DRC – Rail Transit Appt.'s – Second Review Meeting

RE: Responses to Questions and Comments raised in Connection Ashland Rail Transit Apartments

Re: SUPPLEMENT NO.1 Ashland Rail Transit Apartments -Response to Comments from:
Design Review Committee Public Meeting held December 1, 2015.

EXHIBIT A CROS-SECTIONS FROM HIGH STREET TO BUILDING #7 | 2.28.15

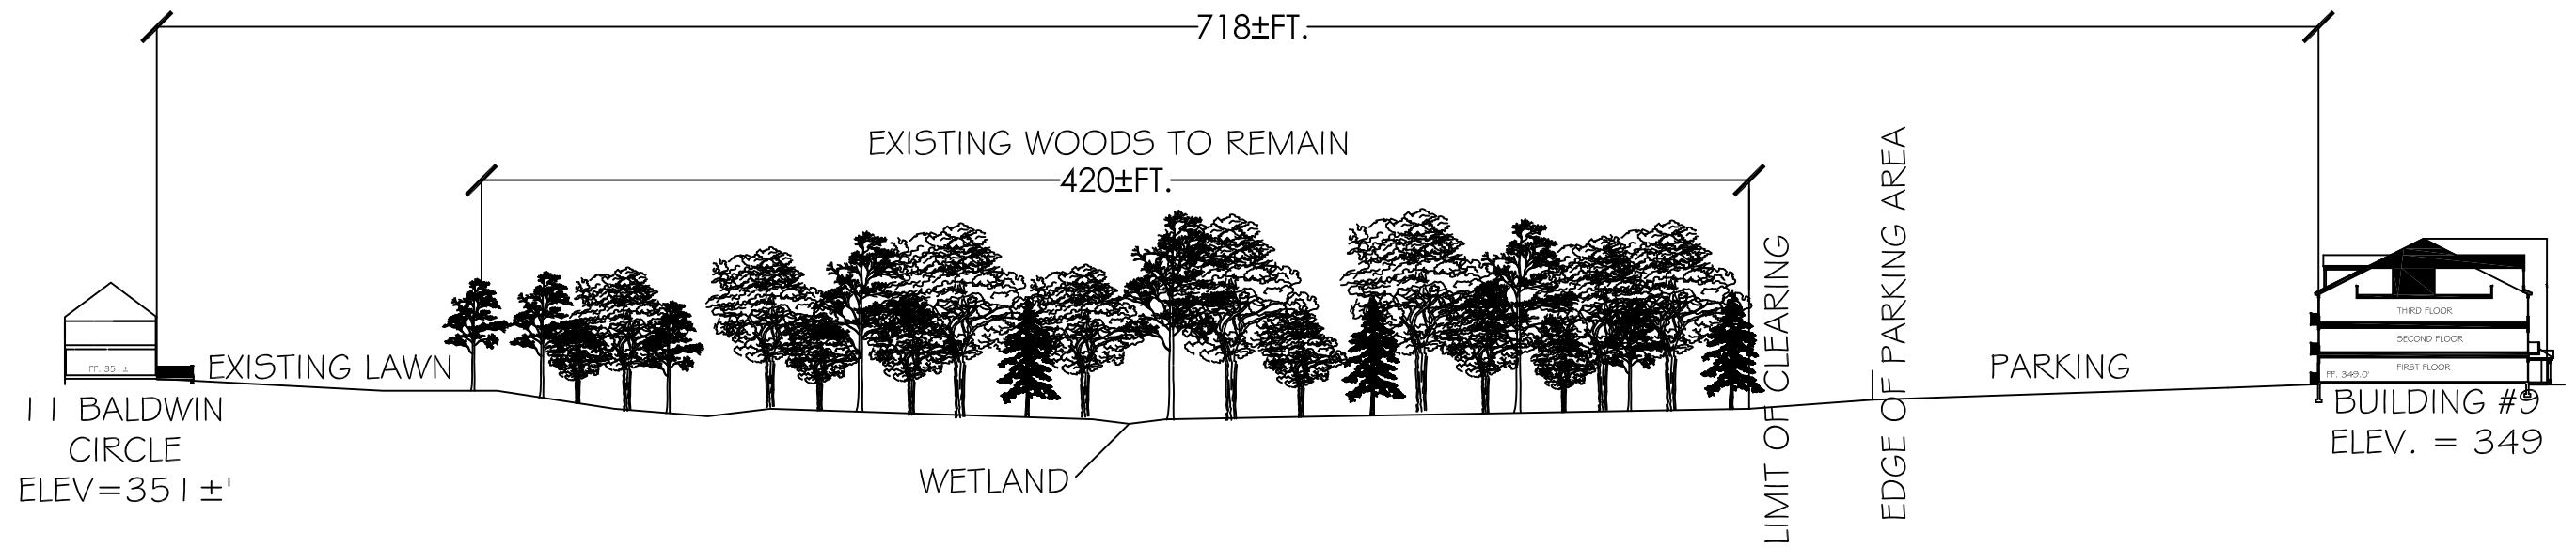
11. Will the apartments be visible from High Street. There are no plans to alter the land near high street with the exception of the emergency access road. The resident requests a drawing /view of the apartment complex from High Street. The developer suggests flagging the corner of the building and the edge of clear cutting on the site as an alternate to the drawings. The resident is open to this solution.

13. Would like to see topography plans - Existing vs Proposed to determine if buildings will be visible from High Street. . The current presentation is schematic only.

Response: Yes they will be visible from High Street as least on a seasonal basis. Exhibit A shows the cross-section from High Street to the closest Residential Building (Building #7). Most of the vegetation to remain is deciduous which becomes relatively transparent in the winter. Exhibit B shows the relationship between 106 High Street and the Proposed Community.

Response: Exhibit A shows the relationship between High Street and Building #7. The building that faces High Street is 3 stories in the front and 4 stories tall on the back. The 4 story façade will face High Street. Exhibit B shows the relationship between 11 Baldwin Circle and the Proposed Community.

EXHIBIT C – TYPICAL EMERGENCY ACCESS GATE

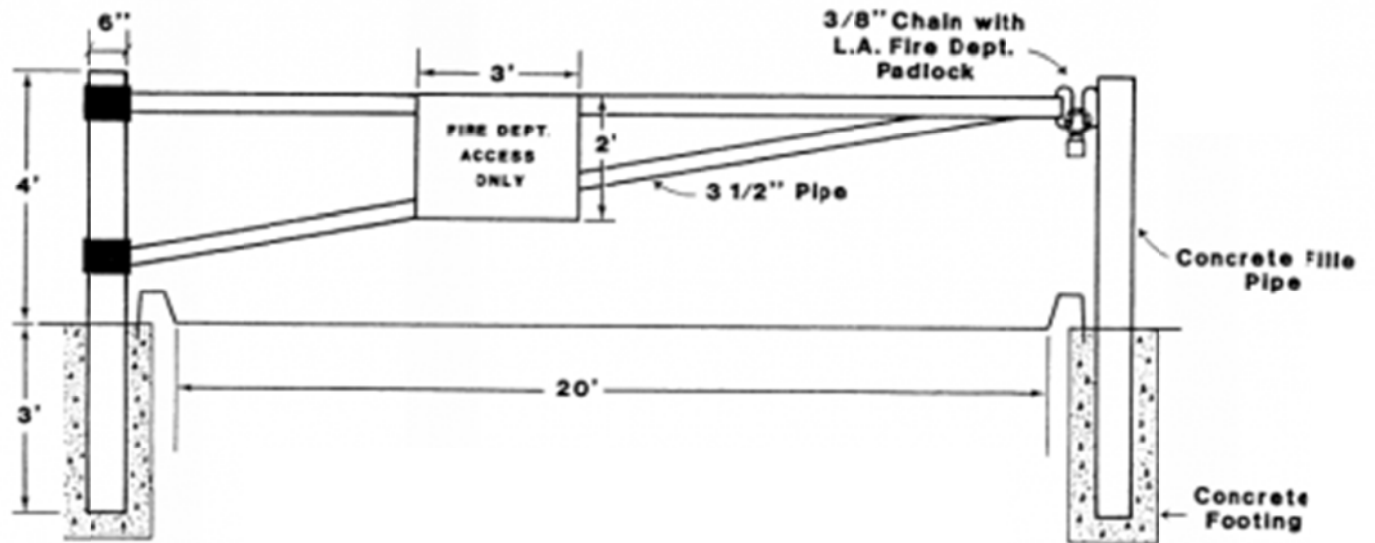
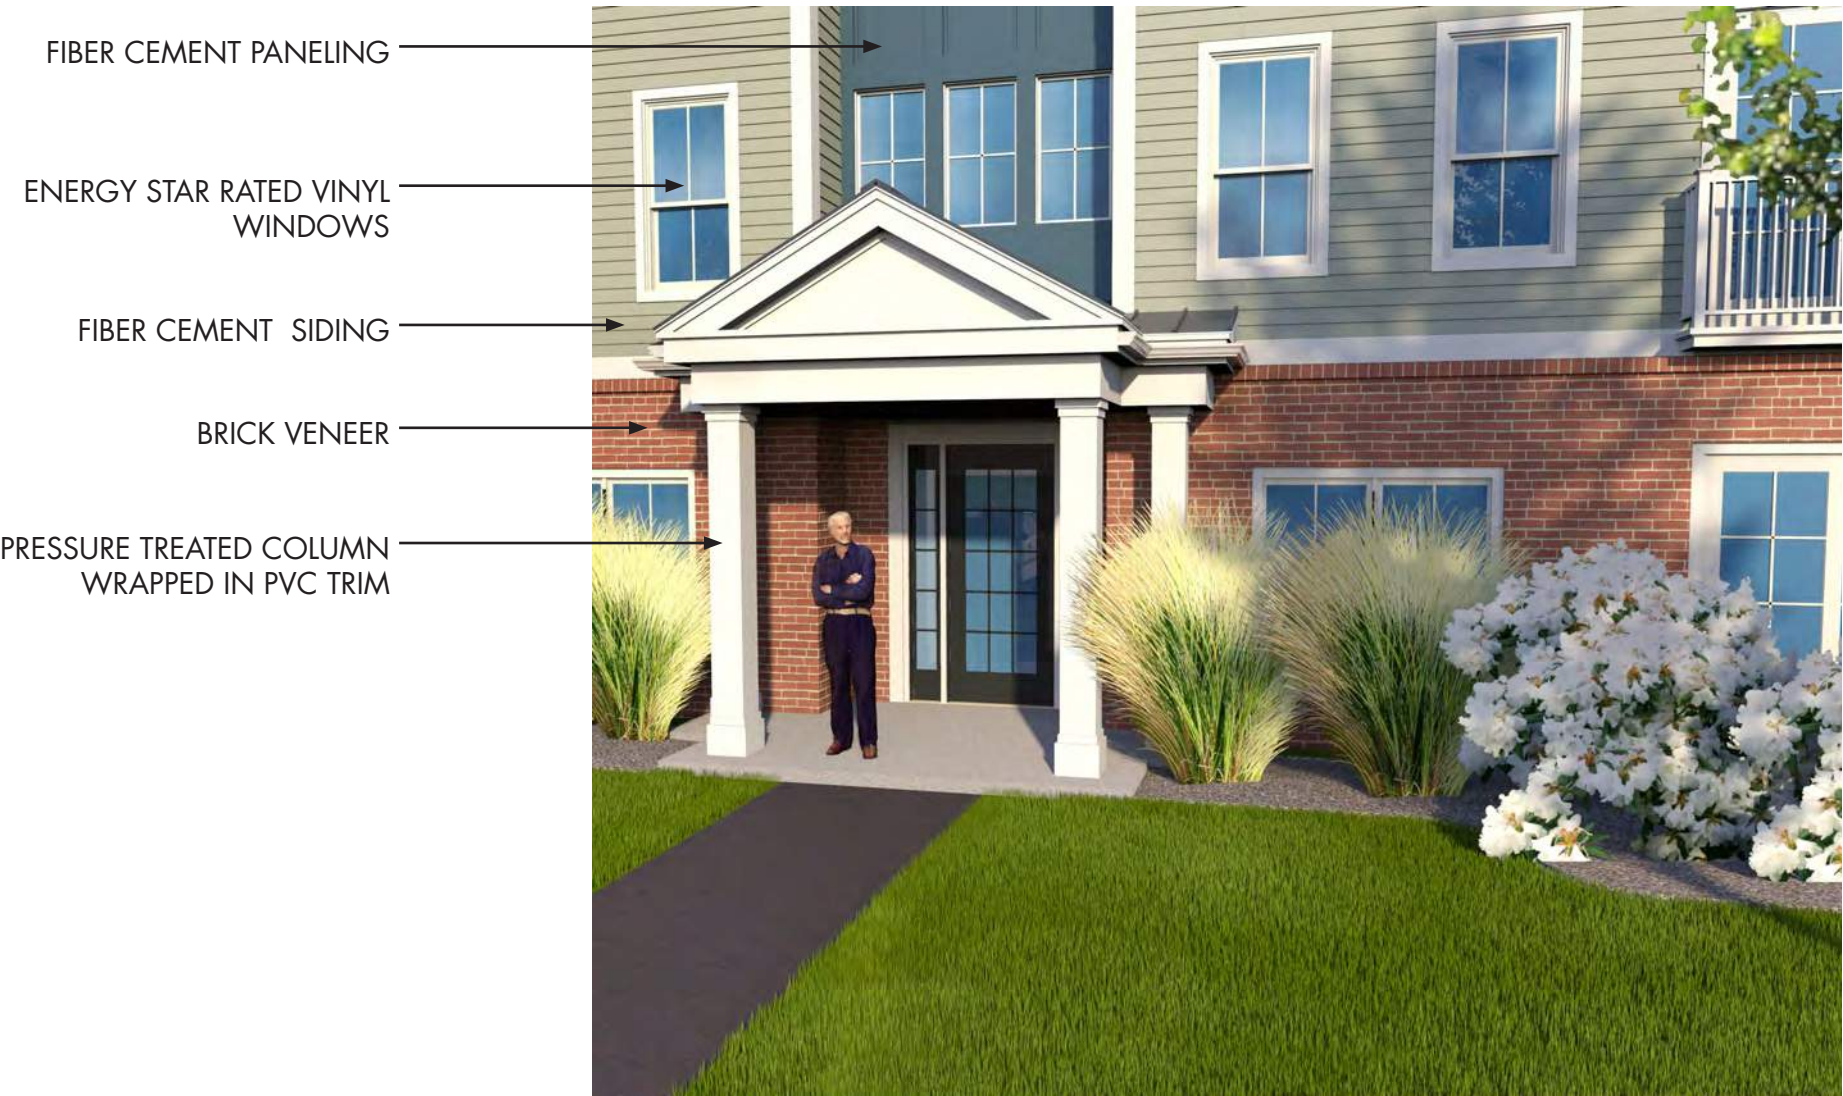
12. Will this design review committee review the emergency access road? It will be a single lane road with a gate to serve the emergency road. What will the gate look like?

Response: Exhibit C shows a typical Emergency Access Gate. Final Design subject to Hudson Fire Department Approval.

EXHIBIT E - ARCHITECTURAL RENDERINGS - TYPICAL FRONT ELEVATION

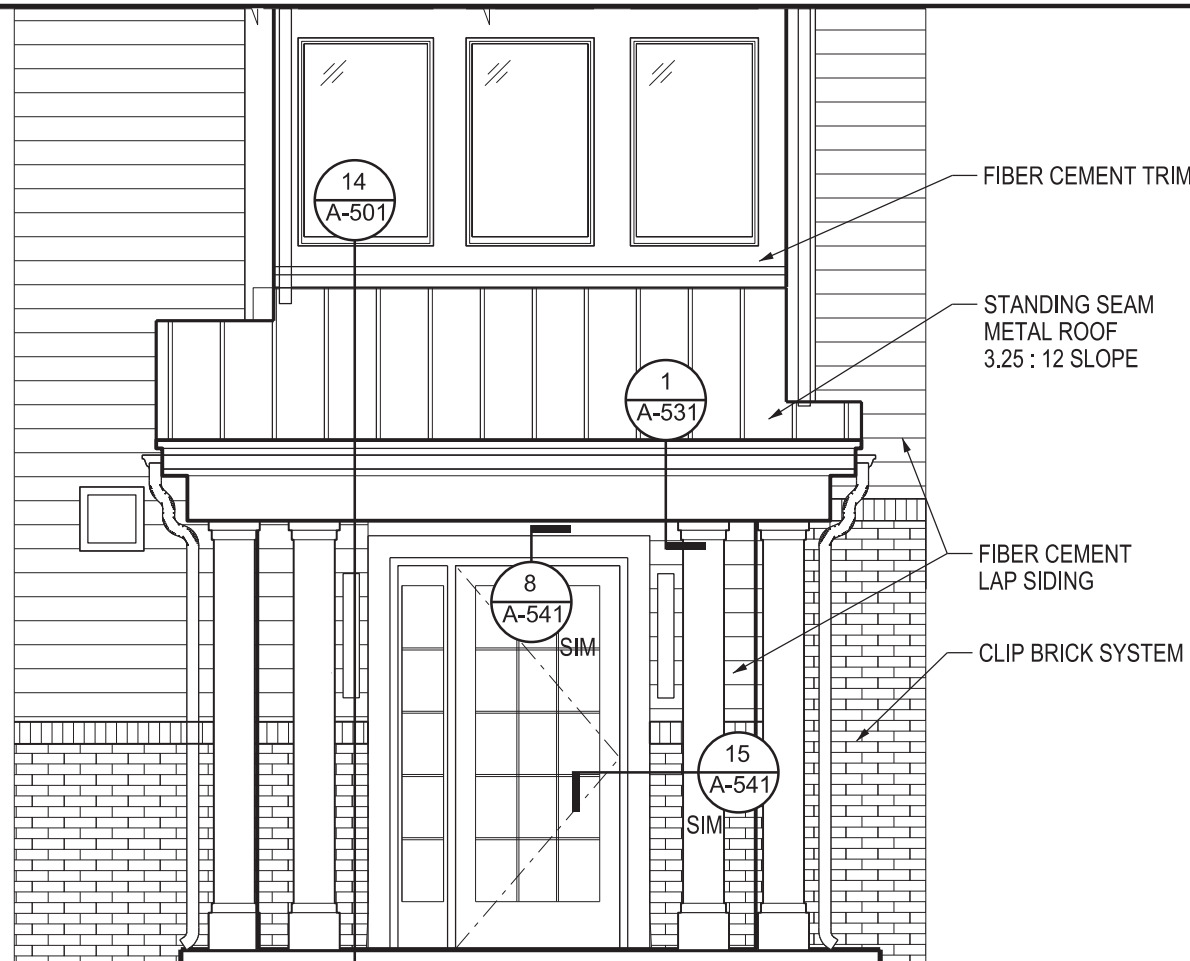
2. EIFS gets dingy after several years. It collects dirt. Metal panel roofs might look industrial. Suggest architectural shingles in place of metal roofs.

7. DRC would like to see a clapboard elevation.

8. The DRC respectfully asks that a second design review take place as the project develops further including: EIFS details (Moulding Details, Cosmetics), landscaping plans, multi-color schemes of apartment buildings, Metal roofing / architectural shingle, options, topography plans per resident requests, water management at curbing, signs, site lighting and site furniture cut sheets.

The applicant is now putting forward buildings clad in a combination of face brick and fiber cement horizontal siding (commonly referred to as Hardi-Plank).

Response: See Exhibits E and F
